Stiltsville Fish Bar -Rooftop Dining

Application DRB20-0548
Modification to Approved DRB #23220

Site Location
1787 Purdy Ave.

Proposed – First Floor

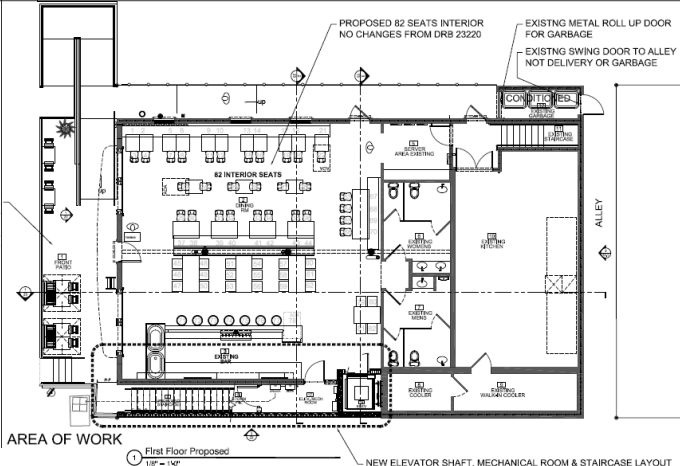
PROPOSED CHANGES/ SITE CHANGES

- ROLL UP STOREFRONT REVISED
- CITY SIDEWALK RENOVATED

MAX
15 SEATS
OUTDOOR
NO CHANGES
FROM DRB 23220

Proposed -Second Floor
 140 seats roof & first floor,
 No additional seats requested.

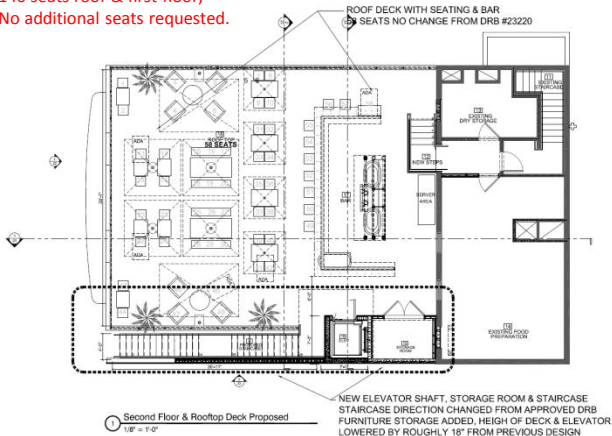
PROPOSED CHANGES/ SITE CHANGES

-9 SEATS ADDED FROM 12/15/15

-EGRESS ROUTE UPDATED (STAIR ACCESS THROUGH BUILDING NOT SIDEWALK)

Proposed -Elevations

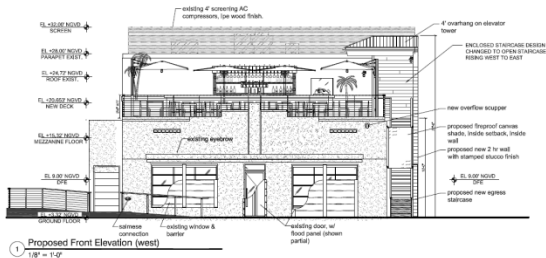
PROPOSED CHANGES/ SITE CHANGES

- STAIRCASE RISES EAST TO WEST (ENCLOSED)
- SIDEWALK ELEVATION

Proposed -Section Through Building

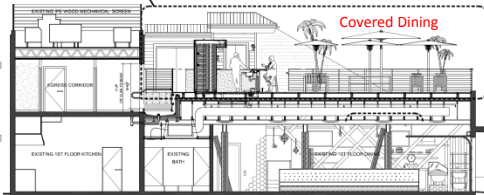
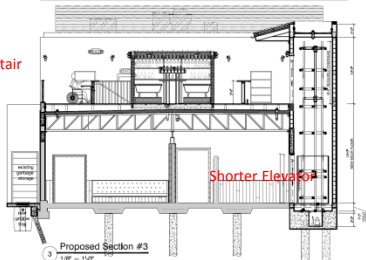
ARCHITECTURAL
ALTERATION

RISE OF STAIR DIRECTION CHANGED FROM WEST TO EAST

STAIRCASE SIMPLIFIED, EXTERIOR, OPEN TO SKY

CANOPY REMOVED, DECK AND ELEVATOR HEIGHT REDUCED $\pm 18"$

Open Stair

Shorter Elevator

Proposed –Rendering (South Elevation)

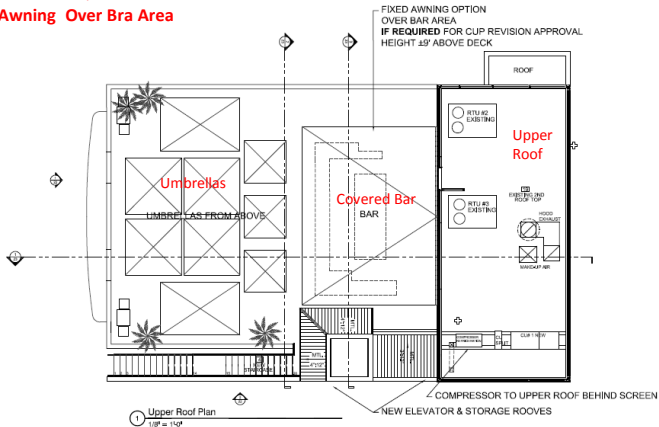
PROPOSED
NEW STAIR ORIENTATION AND MECHANICAL ROOM ON
ELEVATOR SHAFT
